Ref DA: D/2023/299, 181 St Johns Road GLEBE NSW 2037  
Attention: Mr Christopher Ashworth

The development application is for the demolition of a single storey free-standing mid-Victorian house (Figure 1) which is a Contributory item in the Hereford Forest Lodge Heritage Conservation Area, its replacement by a pair of conjoined three storey houses (Figure 2) and to carry out a subdivision.

Figure 14 The building footprint in the 1889 NSW Department of Lands, plan, SLNSW

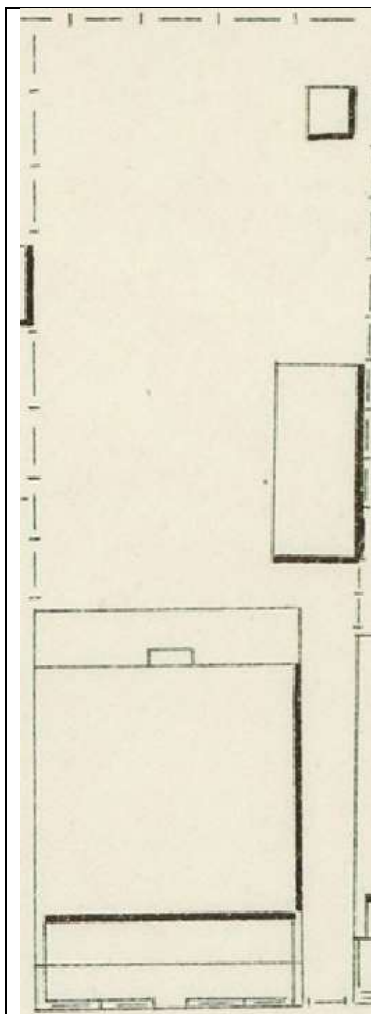
Originally the house had either a shallow skillion, or verandah at the rear and a detached outbuilding (see fig 8 below). The detached outbuilding no longer exists. The current skillion, with its concrete slab floor, is either substantially or entirely a modern addition.

The elevations, form, chimney and plan of the original house are intact. The front elevation to St Johns Road with its original sash windows, verandah and palisade fence is highly intact as is the south west front room with its chimneypiece. The rear building is of no significance and the skillion at the rear of the original house is of little or no significance – see Figs 14, 15, 16, 17, 18, 19 & 20.

Figure 25 The skillion wall on the western side of the house was built in two stages. The brickwork of the northern end was not tied into the earlier wall. The crack relates to the method of construction rather than subsidence

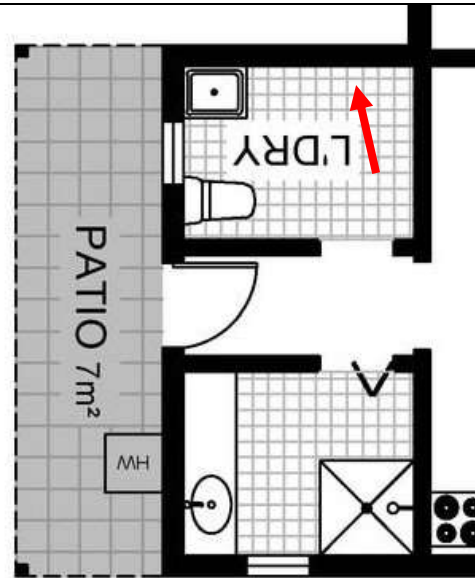
Figure 24 The structural report attributes the crack in the brick wall on the western wall of the skillion to subsidence when it relates primarily to the method of construction, see Fig 25

Figure 29 The site provides opportunities for development while retaining the 1871 house

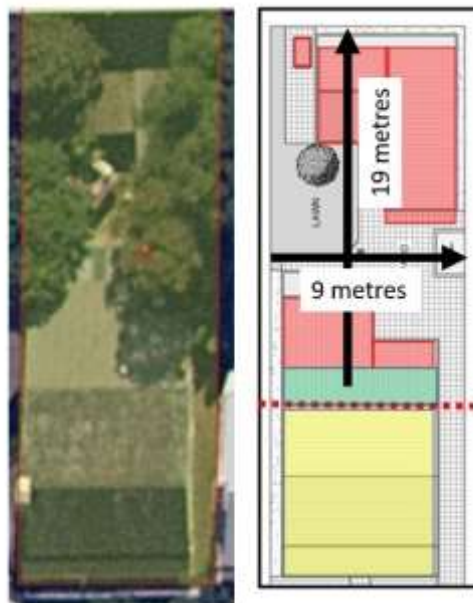
As shown in figure 29 the site provides opportunities for additional development without demolishing the original house.
